Comments to State Water Control Board

August 10, 2018 (REVISED - August 13, 2018)

Part I: Mountain Valley Watch

Figure 2: Additional stream and flow channels, not identified in MVP filings, contribute significantly to volume of flow of water draining from ridges. Click image for access to interactive map.

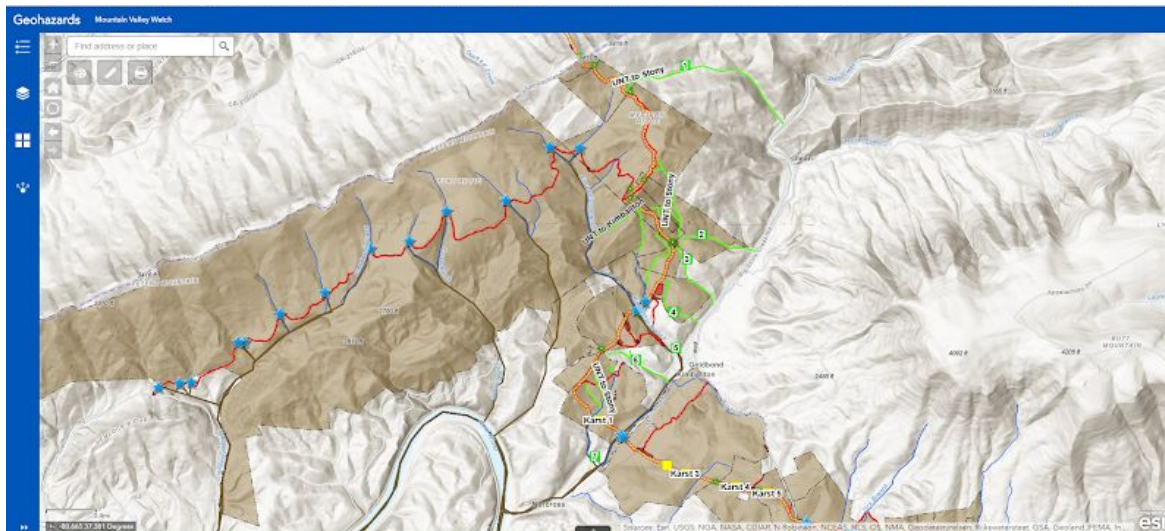
The map in figure 2 gives an overview of the construction corridor over Peters Mountain. It is apparent that not all stream or flow channels are taken into account. The blue stars show MVP identified stream crossings, however a number of flow channels (marked green) were not identified as “streams”. Omitting these surface and underground water channels gives an incomplete analysis of upland water channel flow and their significant contribution to the flow of water coming off the ridges into karst terrain. Observations show that the 125 foot wide construction corridor with water diversion bars produces erosion gullies in the center and along the perimeter of the construction corridor. These erosion gullies typically flow to the lowest point at the toe of a steep slope where the BMP fails due to lack of capacity to control the flow of runoff and sediment. The diversion bars are designed in the construction details to include a small stone outlet structure with gravel filter and silt fence. Small retention areas constructed in clay rich soils as outlet structures along the entire Virginia route are not draining. The structures fill up after the first rain event and overflow with each successive rain event.

Figure 10: Potential violation reported - May 13, 2018

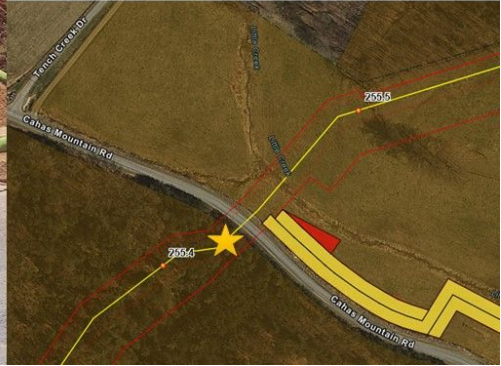
Lack of gravel; inadequate E&SC; mudslide; sediment leaving construction site; failed BMPs.

Figure 12: Potential violation reported - June 13, 2018

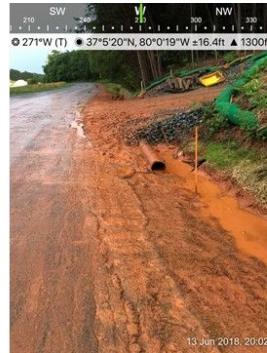
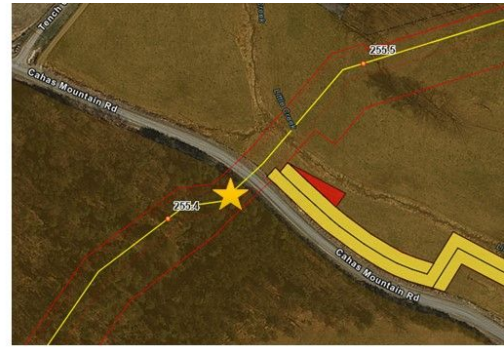
Lack of gravel , Mud or sediment on main road

Figure 21: Aerial image from 8/5/2018 (left) and a pre-construction aerial (right) show drainage and sediment impacts from MVP construction ROW to neighboring pond. Blue lines indicate flow direction into and out of the pond.

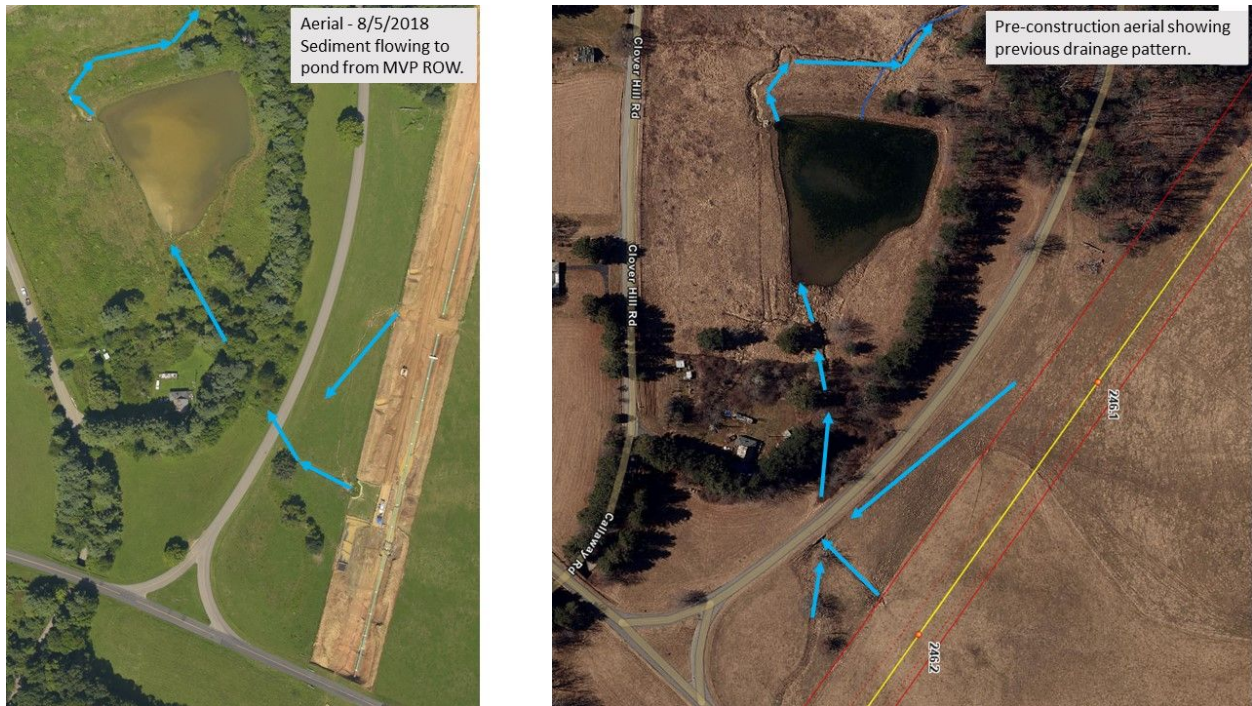
The perched aquifer has been breached at the Blue Ridge Parkway crossing. During both rain events and dry periods, the pipe beneath Route 221 and the Blue Ridge Parkway has been submerged in groundwater that continues to pool in the trench. This perched aquifer is the groundwater for the Bent Mountain community, and feeds residents' wells — their only source of drinking water. Dr. Pamela Dodds, an expert hydrogeologist, prepared a report on the perched aquifer of Bent Mountain in which she stated that "deforestation, soil compaction, and dewatering [during pipeline construction] will permanently deplete groundwater flow through perched aquifers in the Mill Creek watershed to seeps and springs that provide water to wetlands, headwater areas, stream baseflow, and residential wells, and will permanently reduce the groundwater hydraulic gradient." (Dodds, P.C. 2017) See figures 20 and 21 for location of the Blue Ridge Parkway crossing, pictures of groundwater in the trench, and an aerial photo showing sedimentation of source water point for Mill Creek.

Figure 25: Images from incident reported on June 22, 2018. SMN-21 impacted.

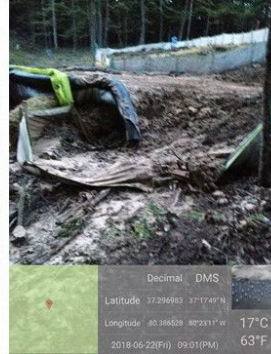
- evidence of sediment leaving the construction site
- evidence of flooding at the site
- evidence of structural damage at the site
- evidence of erosion at the site
- ROW diversions are not installed or functioning properly

- fence is damaged, collapsed, un-entrenched or otherwise ineffective
- sediment has not been removed per maintenance requirements
- silt fence not properly located and installed

- mulch not distributed uniformly on all disturbed areas
- mulch not applied at an adequate rate

Figure 26: Images from incident reported on June 22, 2018. SMN-21 impacted.

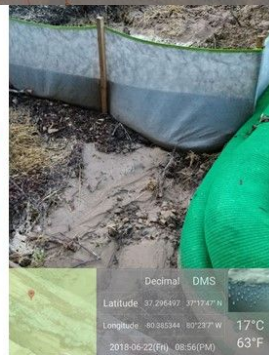
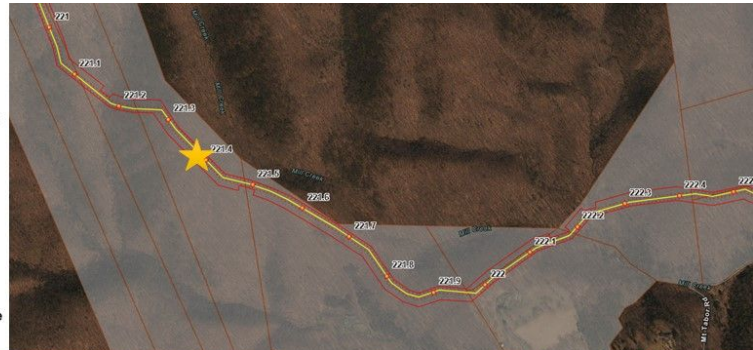
- evidence of sediment leaving the construction site
- evidence of flooding at the site
- evidence of erosion at the site

- fence is damaged, collapsed, un-entrenched or otherwise ineffective
- sediment has not been removed per maintenance requirements
- silt fence not properly located and installed

Figure 28: Photos from June 23, 2018 reported incident on Powell property

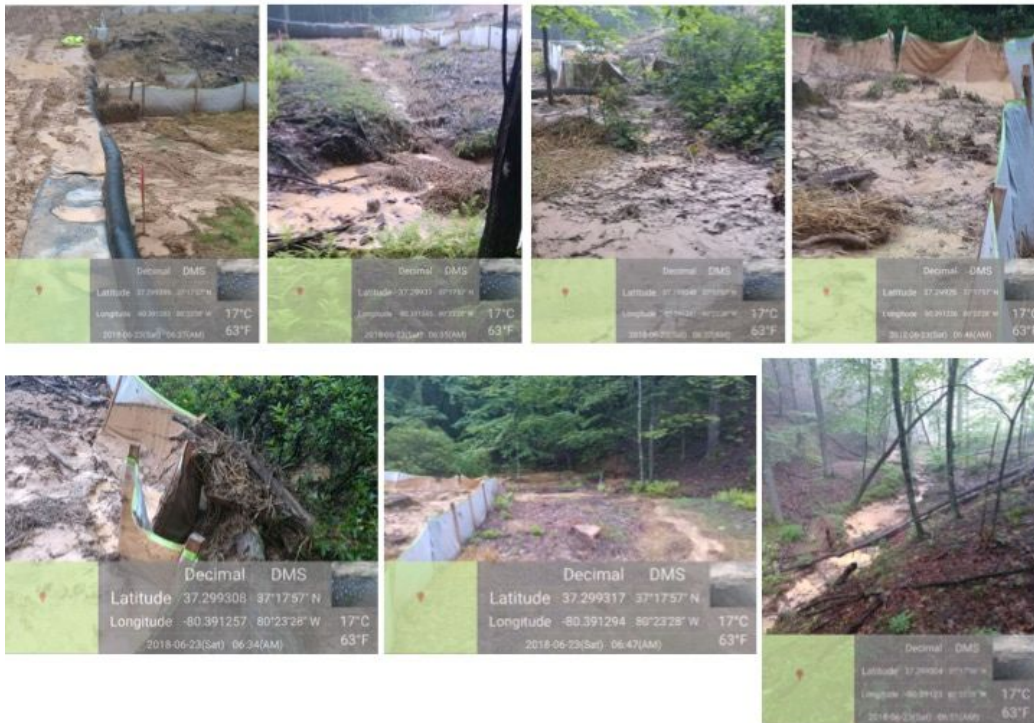
- evidence of sediment leaving the construction site
- evidence of flooding at the site
- evidence of erosion at the site

- fence is damaged, collapsed, un-entranced or otherwise ineffective
- sediment has not been removed per maintenance requirements

Figure 29: Photos from June 22, 2018 reported incident on Triplet property

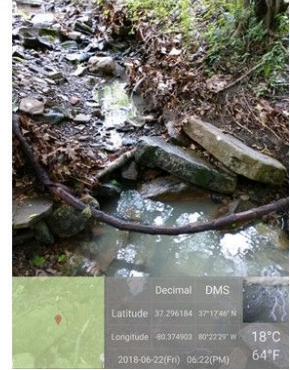
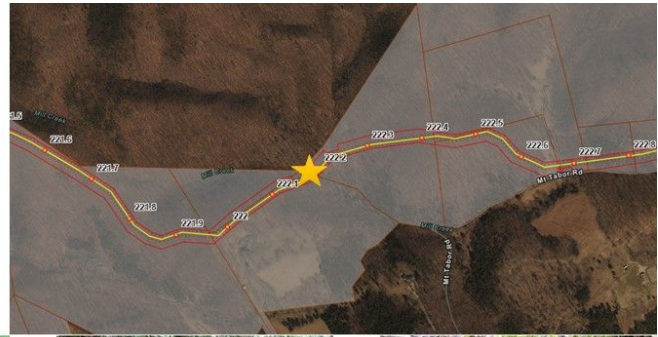
- evidence of sediment leaving the construction site
- evidence of flooding at the site
- evidence of erosion at the site

Figure 30: Photos from June 26, July 17, and July 22, 2018 reported incidents on Dyer property

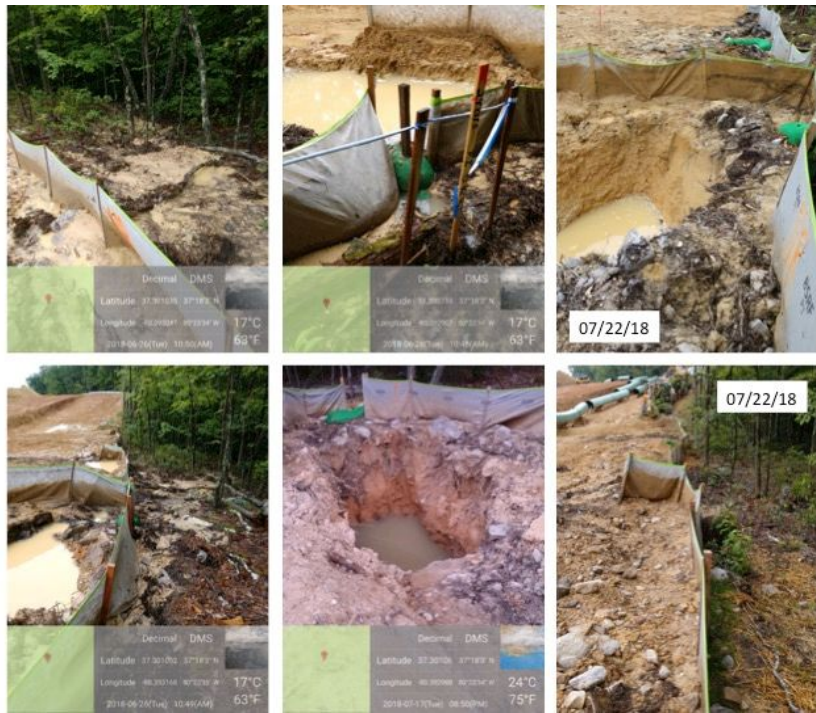
Failures in the area continued to June 26, 2018 on the Dyer property, shown in three photos below where sediment is leaving MVP's construction right of way.

Despite DEQ's issuance of a Notice of Violation July 9, 2018 and MVP's subsequent voluntary stop work to repair ESC measures, the Slusser's Chapel Conservation area continued to see erosion and sediment control incidents, with additional ESC failures reported on the Dyer property July 17 and July 22, and on the Slayton property July 22, 2018. The images shown below are from those reports. One image in figure 31 from the reported incident on the Slayton property shows the stream bed clogged with mud as a result of repeated failures.

Figure 36: Aerial image from August 5, 2018 flight showing buried farm equipment and flow path at the Gallagher property.

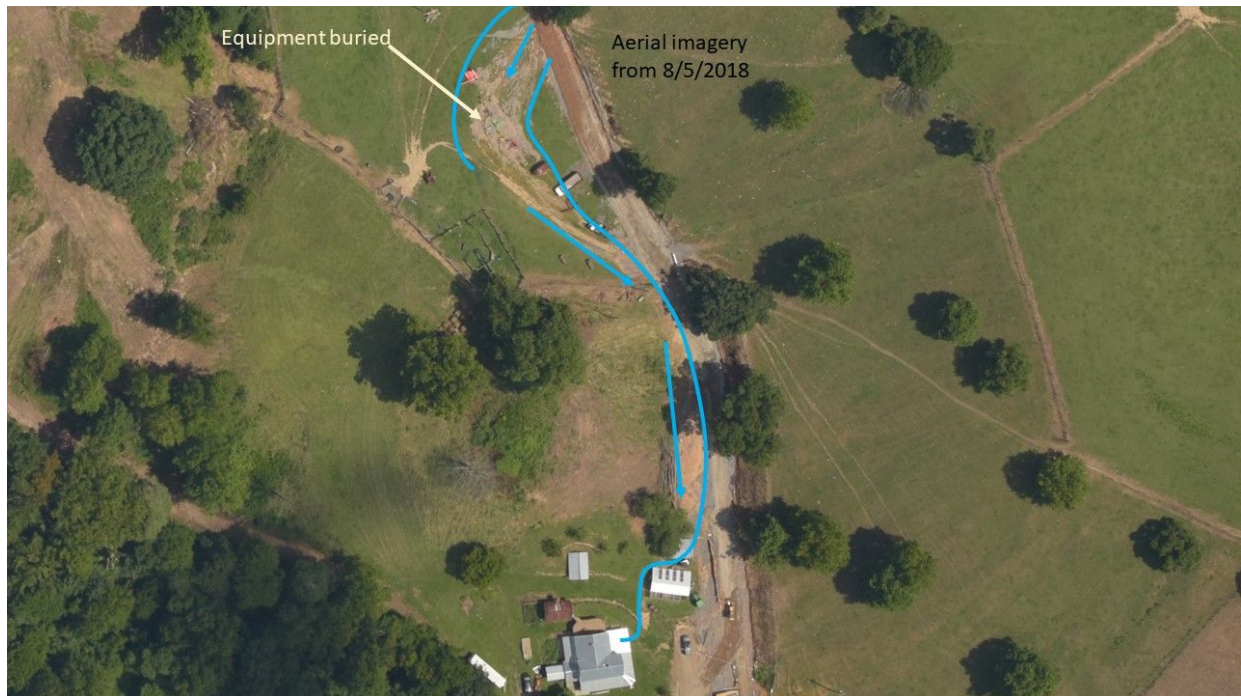
As of the writing of this report, three major failures (on 7/21, 7/31 and 8/2) had occurred at the Gallagher property. Grading for an access road redirected runoff toward the house and chicken coop. Both the chicken coop and basement of the house were flooded. Figures 34-36 illustrate the resulting damage. As part of the continued updating of this report a fourth and the most significant failure to date occurred today 8/13/2018. We are collecting images and will update report.
